PCN – Product Change Notice

PCN #: 060602

All V•I Chip PRMs, BCMs, and VTMs

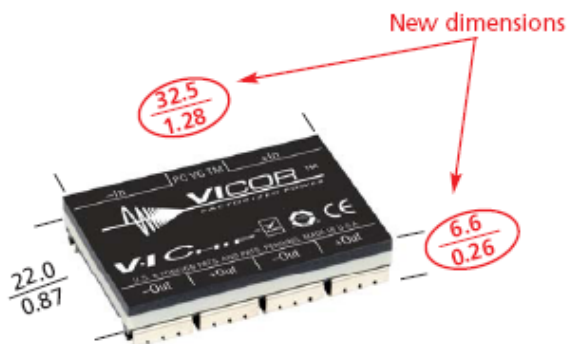
The package size will increase by 0.020" / 0.50mm in the Y-dimension (long dimension) and by 0.012" / 0.30mm in the Z-dimension (height). No change to pcb pads location or spacing is required.

Existing V•I Chip package
(Date code 0634 and earlier)

New V•I Chip package
(Date code 0635 and later)

This change may affect adjacent component spacing and clearance holes (on the PCB) used for heat sink push pins or other mechanical fastening systems. Heat sinks and push pins are available from Vicor which accommodate the new package dimensions. Automated assembly / test equipment used to place and / or test V•I Chip products on the PCB (with critical tolerances) should be considered.
